SUBJECT: Duke Energy Carolinas, LLC (Duke Energy)  
McGuire Nuclear Station, Units 1 and 2  
Docket Nos. 50-369 and 50-370

Final Responses to NRC Request for Additional Information (RAI) related to Generic Letter (GL) 2004-02, "Potential Impact of Debris Blockage on Emergency Recirculation During Design Basis Accidents at Pressurized-Water Reactors"

Preface to Final McGuire Responses  
Generic Letter 2004-02 Supplemental Response  
November 18, 2008 NRC Request for Additional Information

**Figure 13S-1: Top Hat Strainer Module Submergence  
 Vortex Test Condition**

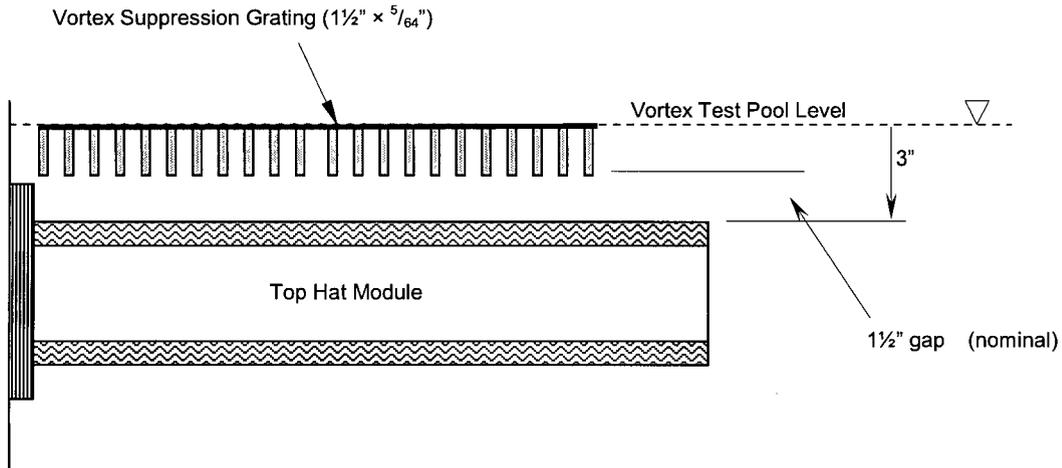
13. The conditions under which vortex testing was conducted for McGuire, and the plant conditions for which the testing was being conducted, are not clear from the available documentation. Based on the information provided to date, the NRC staff has been unable to determine what conditions resulted in vortex formation and whether the modifications made to eliminate vortices were tested under conditions that conservatively represented those expected in the plant post-LOCA. Vortex testing was conducted at 3-inch submergence (as stated in the Duke Energy Carolinas (Duke) response to RAI question 39 in Enclosure 1 to the supplemental response dated February 28, 2008), which is greater than the expected 2-inch minimum submergence for a small break loss-of-coolant accident (SBLOCA) (as stated in Section 3(f)(2) of Enclosure 2 of the supplemental response). Note that Duke further states in its response to RAI question 39 in Enclosure 1 that the minimum submergence for the strainer is expected to be "at least" 2 inches and separately that it is "about" 4 inches (Enclosure 1, pages 35-36). Enclosure 2, Section 3(f)(2), also states that the strainer is submerged by at least 2 inches while Enclosure 2, Section 3(f)(3), states that the grating is submerged by at least 2 inches. Enclosure 2, Section 3(f)(3), also states that the testing was performed with a "few inches" of submergence. This set of disparate strainer submergence values does not provide a coherent description of the test conditions.

Enclosure 2, Section 3(f)(3), states that the testing was conducted at velocities between 0.01 ft/sec and 0.09 ft/sec, while the maximum approach velocity for the strainer is 0.052 ft/sec. The response does not provide a basis for the 0.052 ft/sec, other than the expected maximum approach velocity is greater than nominal by about a factor of 2 (Enclosure 1, pages 35-36), and does not clearly state that testing at or above 0.052 ft/sec did not result in vortices.

- e. Please provide a quantitative value for the submergence level at which the testing was conducted with no vortex suppressors installed. If the level changed (e.g., between SBLOCA and LBLOCA tests), please provide the test conditions for each test.

Refer to Figures 13S-1 and 13S-2 below for the responses to questions (a) through (g).

- e. Referencing Figure 13S-1, the submergence level of the strainer top hat module topmost surface (perforated plate) during the vortex suppression testing was fixed at 3 inches. The vortex testing did not vary the submergence for LBLOCA/SBLOCA; the submergence level

**Figure 13S-2: Top Hat Strainer Module Submergence  
 Plant Condition**

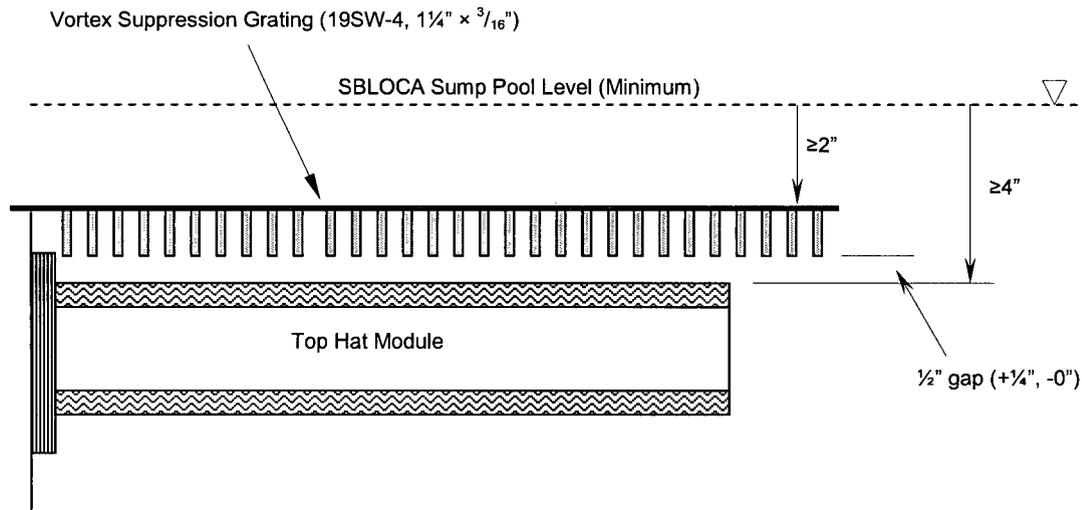
- a. Please clarify what the actual minimum submergence for the strainer is expected to be in the plant.
- b. If different evaluations for vortexing were conducted for SBLOCAs and large break loss-of-coolant accidents (LBLOCAs), please provide details for each evaluation.

- g. Provide a quantitative value for the vortex suppressor submergence in the reactor plant. If some suppressors are installed at different elevations than others, provide the submergence level for each location.

- a. Actual minimum submergence level of the McGuire ECCS Sump Strainer Top Hat modules (pool surface to module perforated plate topmost surface) is  $\geq 4$  inches, as depicted in Figure 13S-2. The minimum submergence level occurs as a result of the SBLOCA scenario.

- b. Vortex evaluations were performed for the McGuire ECCS Sump Strainer design for the limiting submergence level (SBLOCA scenario) only. The testing was performed at a submergence level of three inches, which is less than the minimum predicted SBLOCA submergence level of  $\geq 4$  inches, and therefore conservative. The LBLOCA scenarios generate more pool volume and a higher submergence level. Details regarding the SBLOCA vortex evaluation are located in the McGuire GL 2004-02 Supplemental Response dated February 28, 2008, Enclosure 2, item 3(f)3.

- g. Referencing Figure 13S-2, the submergence level of the vortex suppression gratings in the McGuire plant condition is at least 2 inches at all locations (inside and outside the Crane Wall, as measured from the top of the grating) during a SBLOCA event. The LBLOCA event produces more pool volume and therefore a higher submergence level.

**Figure 30S-1: McGuire ECCS Sump Strainer (typical)**

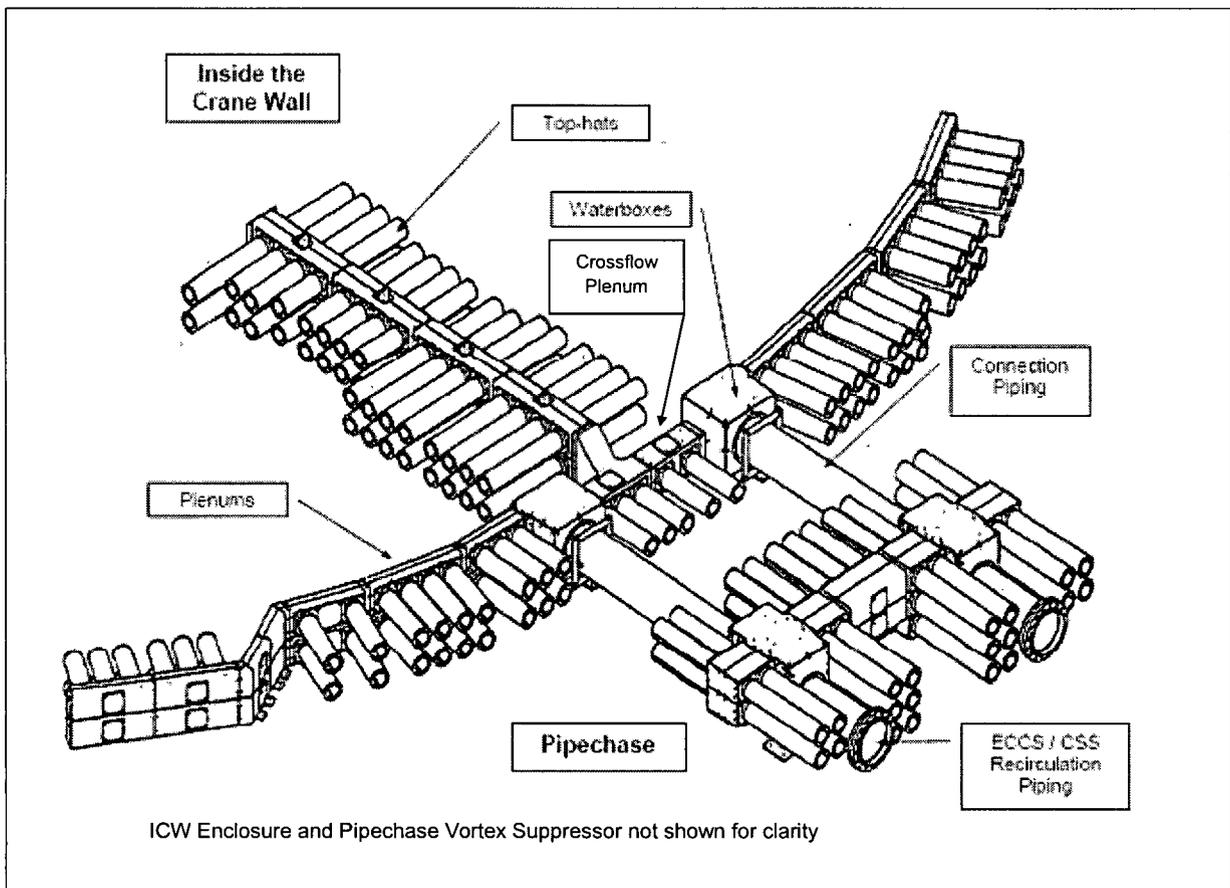
RAI question 30: Identified the Crossflow Plenum of the ECCS Sump Strainer in Figure 30S-1, and added note regarding the use of faulted allowable loads based on NRC feedback from November 1, 2010 teleconference.

As described in the McGuire GL 2004-02 Supplemental Response dated February 28, 2008, the ECCS Sump Strainer is constructed of robust materials and is positioned both inside and outside the crane wall (see Figure 30S-1).
